**TUOLUMNE COUNTY RESOURCE CONSERVATION DISTRICT**

**ADDENDUM #1 FOR**

# TWAIN HARTE SCHOOL STORMWATER PROJECT

MATERIAL
PLAN - ZONE D

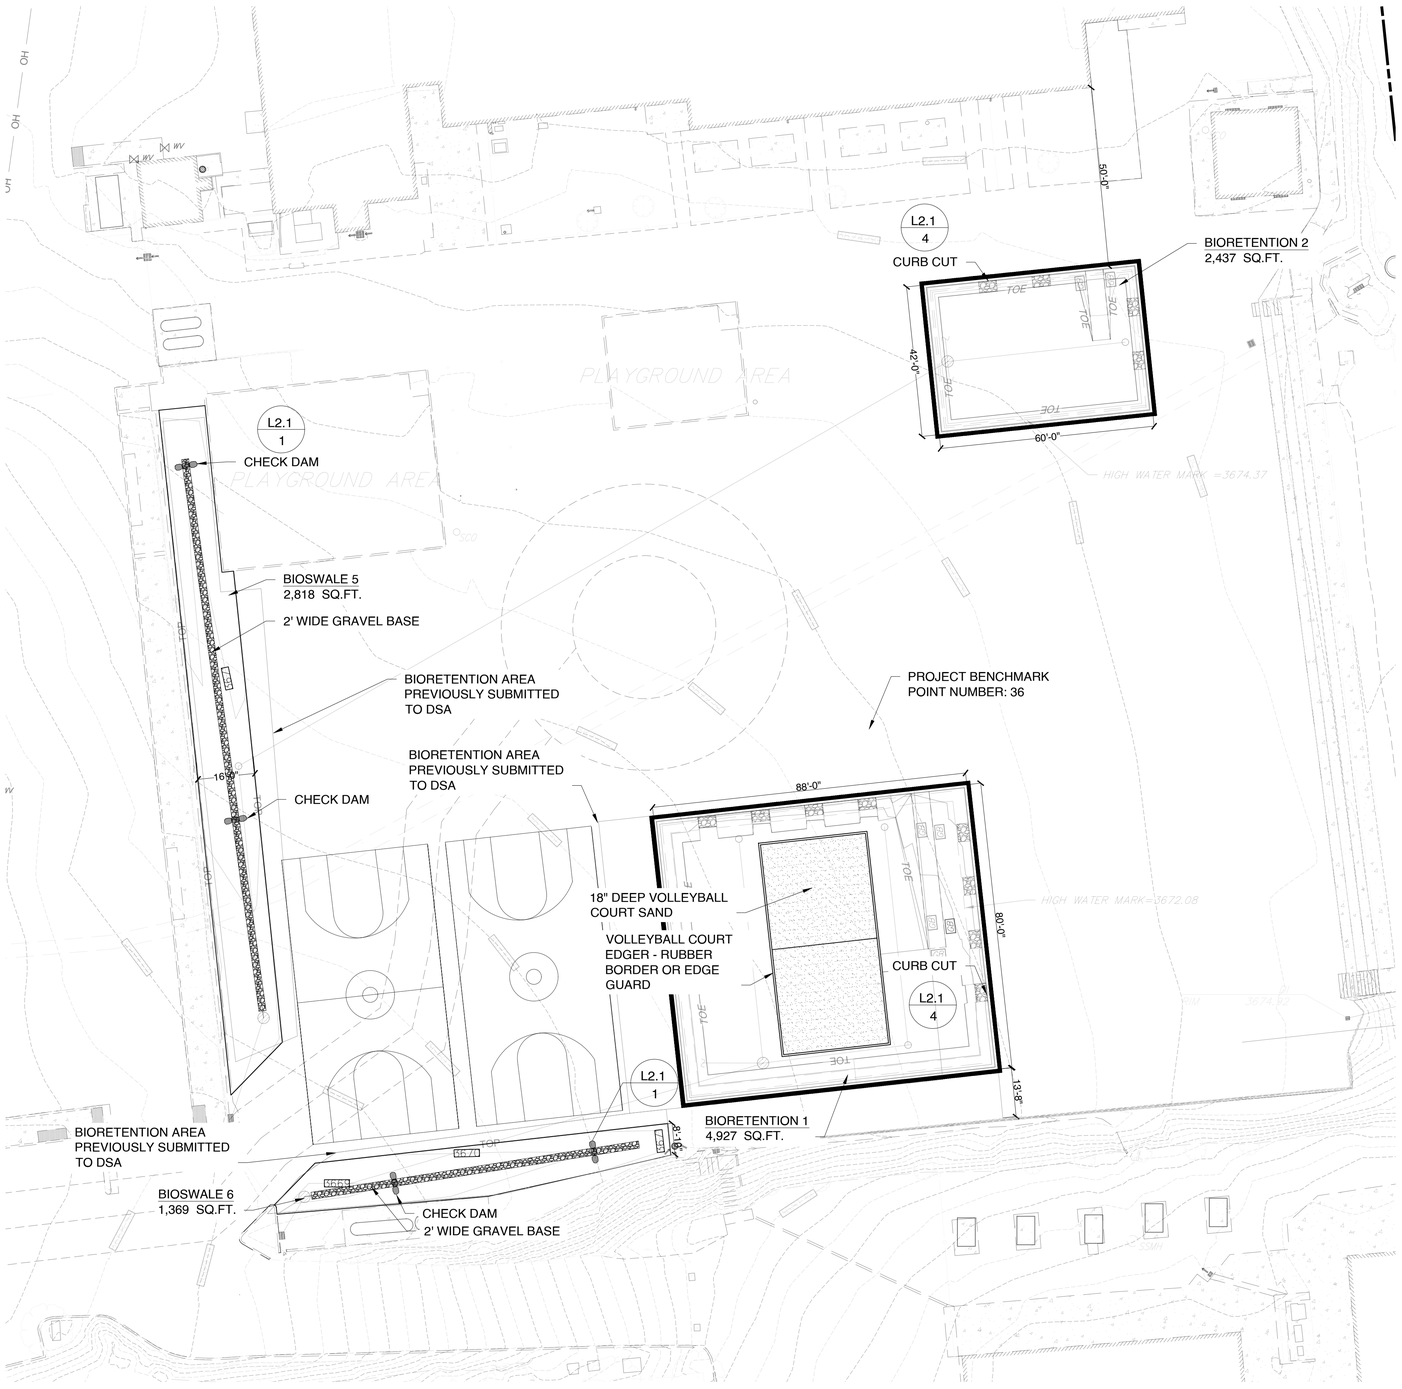
The volleyball court in Bioretention Area #1 will have sand depth at 18" and edger to be rubber boarder or edge guard. See revised Material Plan –Zone D page L2.0.
